ADDENDUM NO. 2

TO: PLANS AND SPECIFICATIONS FOR STATE OF MISSOURI

**Design & Construct New Premium Sites, Campground Network
Weston Bend State Park
Weston, Missouri
PROJECT NO.: X2221-01**

MATCHLINE (SEE SHEET L-400)

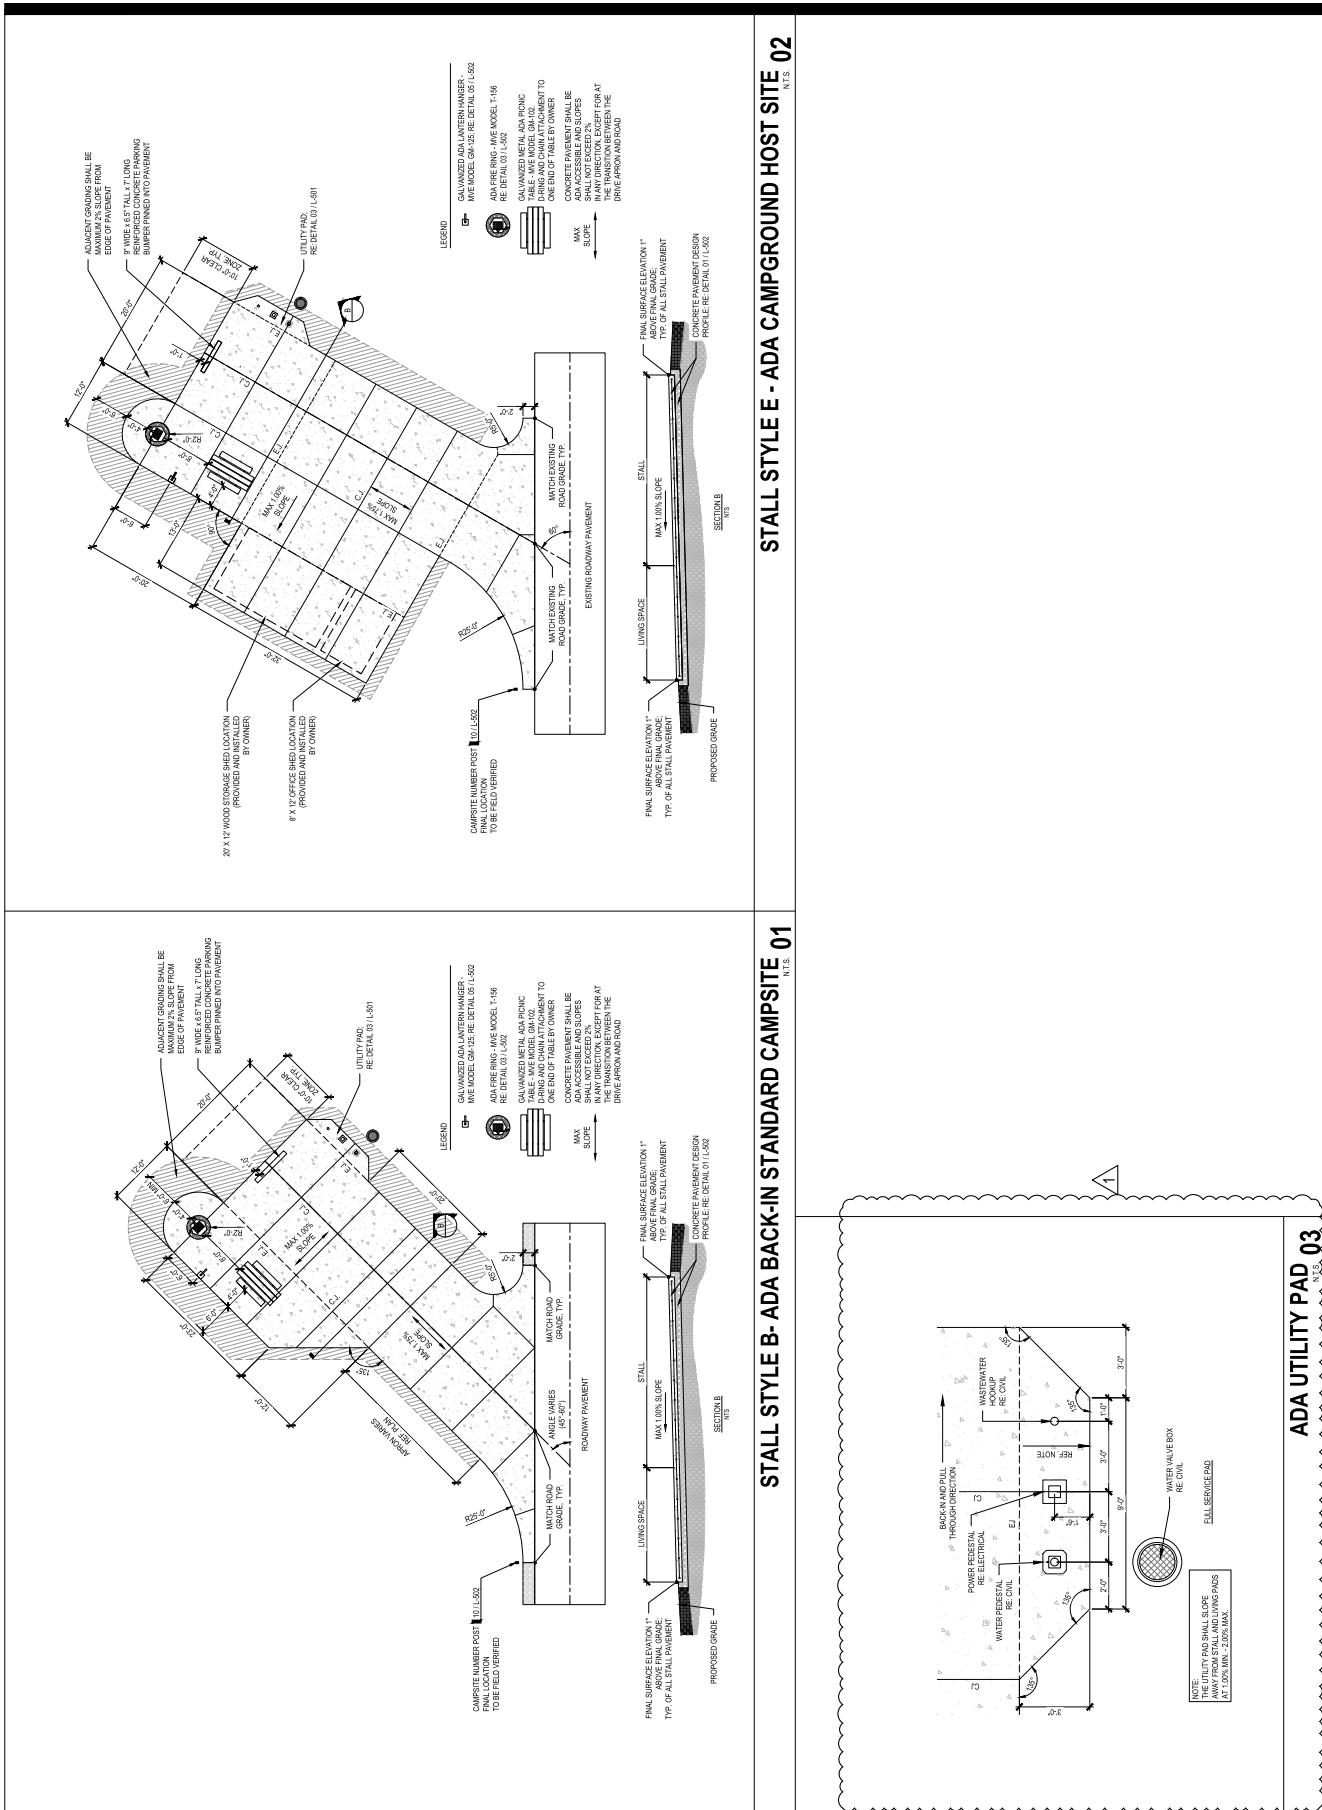
2. **Sheet C-506:** Valve Box Detail, Refer to revised detail attached
3. **Sheet C-102:** septic tank has been removed from the project. A manhole replacement has been added.
4. **Sheet C-404 and C-405:** Pipe sizes added to plan and profile drawings
5. **Sheet C-501 to C-504:** Clean-out locations have been added and called out. Note has been added referencing Spec 333000 for Sanitary Sewer Construction. Septic tank has been removed from project. Sanitary Stub detail has been revised.
6. **Sheet L-500, Detail 3 and Sheet L-501, Detail 3 Utility Pads:** refer to revised details attached. Concrete for utility pads is to drain away from centerline of campsite.
7. **Sheet L-402:** Bottom of wall elevations have been added. See Attached.
